Grants Reclamation Project

Response to October 4, 2007 E-Mail from Ron Linton – NRC

Questions on Evaporation Pond #3

Figure B2-1 Wind Rose of Wind Speeds and Directions

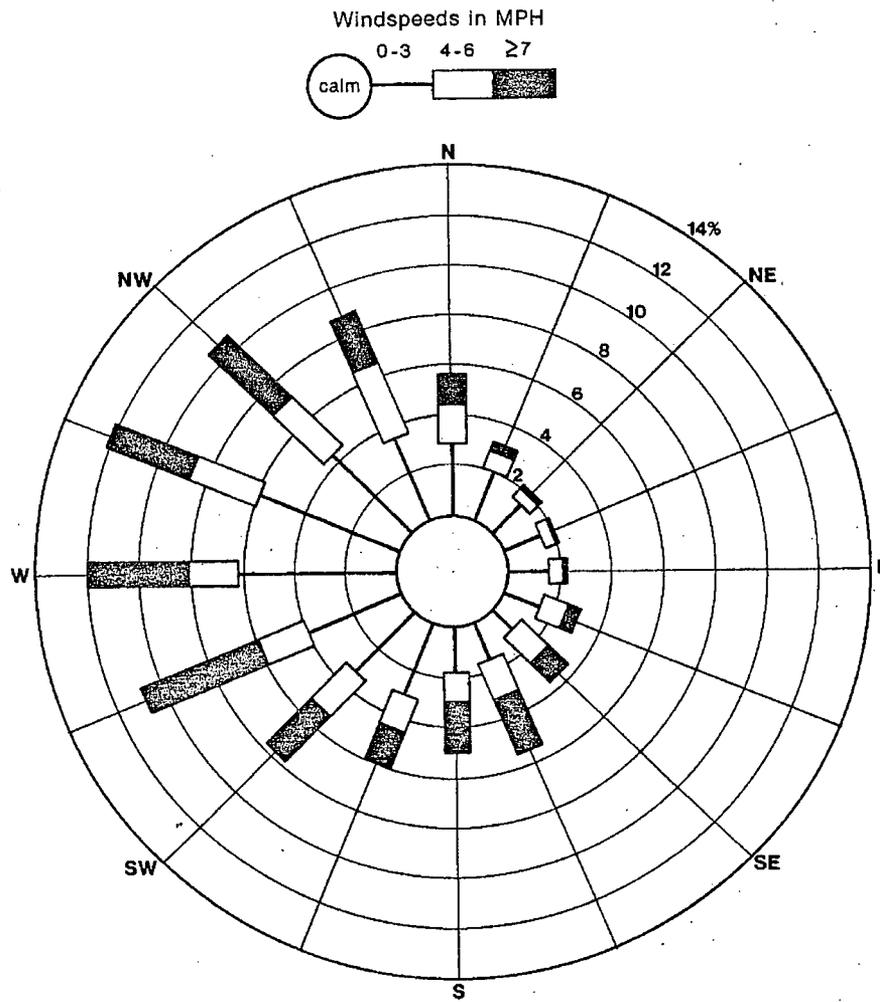
2. Surface winds in the project area are reported in the EA by Bridges and Meyer (2007) (page 10 of 22) as predominantly from the north-northwest. However, HMC reports the predominant wind direction as from the southwest in latest semi-annual report section 2.1. Which is correct?

The Environmental Report by Bridges and Meyer (2007) is making reference to wind data that was obtained from the Grants / Milan airport which is located several miles SSW of the project site. The data from that site does indeed show a predominant surface wind direction from the North-Northwest. The local geomorphology where the airport is located (in a valley between Black Butte and the base of the Zuni Mountains) is believed to have a localized affected on observed wind direction.

Older data from the Anaconda / ARCO Bluewater millsite west of the project, as well as data from our weather station immediately south of the current evaporation pond complex at the Grants project, shows that the higher and more intense winds (related to storm fronts) come from the Southwest. The ER should have had a discussion of the Anaconda data and local site data which are more locally relevant to wind conditions at the Grants site. The following information is provided with regard to the Bluewater site which is the basis for the references made to wind direction in previous project semi-annual reports

Wind speed and wind direction were monitored near the site in 1978 at Anaconda's Bluewater Mill, approximately 5.5 miles northwest of the HMC site (Anaconda 1981). This data is shown below. Average wind speed at the site in 1978 was estimated to be five miles per hour with a prevailing wind speed of five miles per hour and the prevailing wind direction was from the

southwest. Recent wind data reviewed at Bluewater Ridge supports the Anaconda 1978 wind data.
